Mayfield Manchester: Phase 1, MSCP
Planning Statement Addendum

June 2023

1 Planning Statement Addendum

Figure 1 – upper floor car parking layout

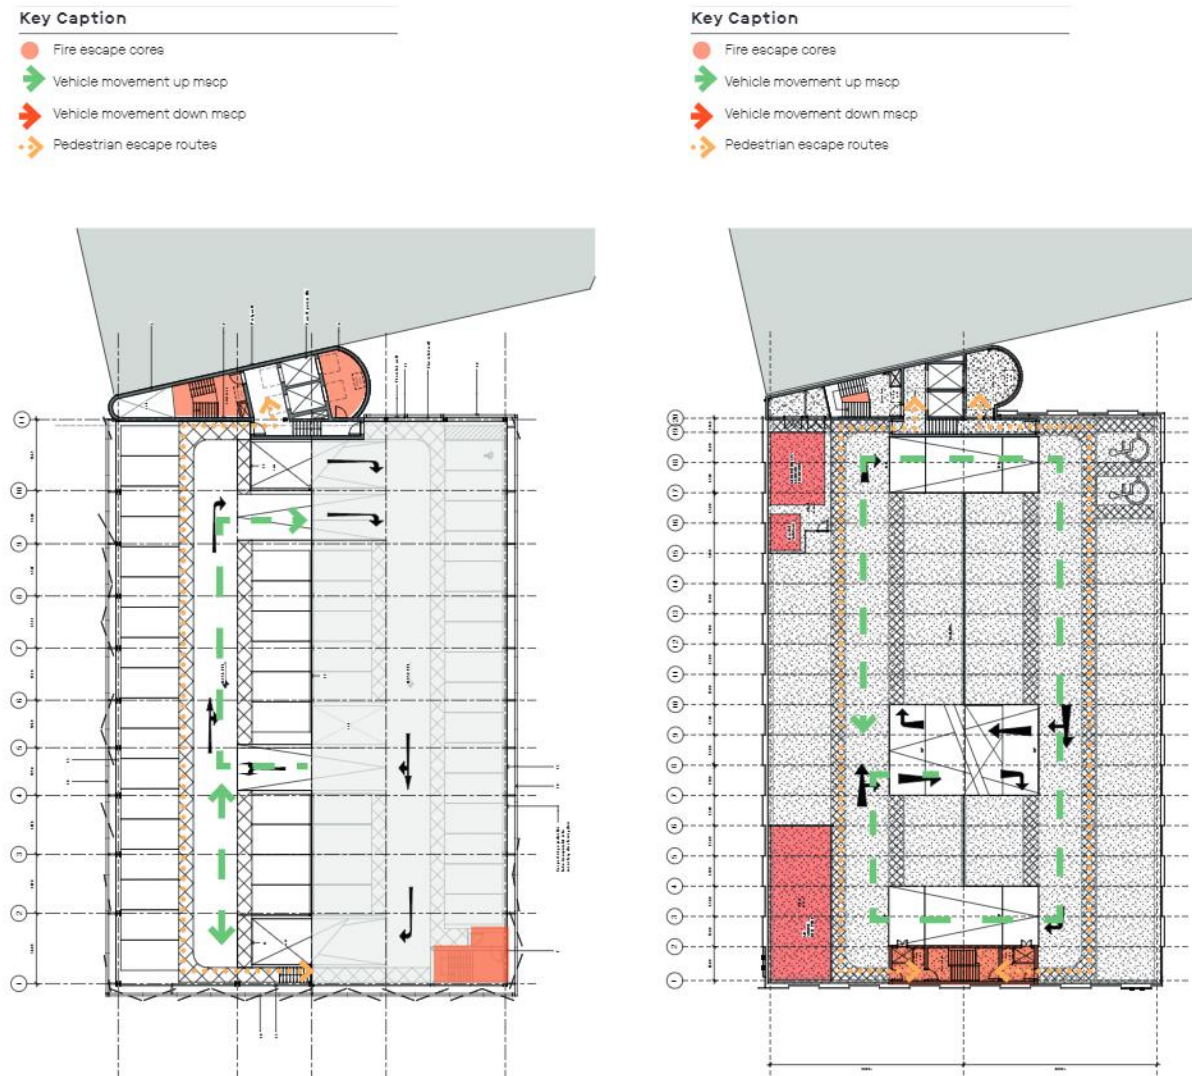
- 2.12 Overall, the individual car parking spaces have been marginally increased in dimension to accommodate the possibility of cars being generally larger in the future, as the public continues to transition to greater use of electric vehicles. Agreement to the layout of car parking spaces is required by planning condition, but an example of the layout of the parking spaces is provided in the typical floorplan shown in Figure 1.

- 2.13 The access and egress to the ground floor has also been amended to provide an entrance for cars to the southern elevation, rather than the western (Baring Street) elevation. This is to separate the pedestrian and cyclist flows into the building from Baring Street and avoid conflict. There are three lanes as part of the car park access / egress and the middle lane will either act as an entrance or exit lane depending on whether it is the AM peak or PM peak time.
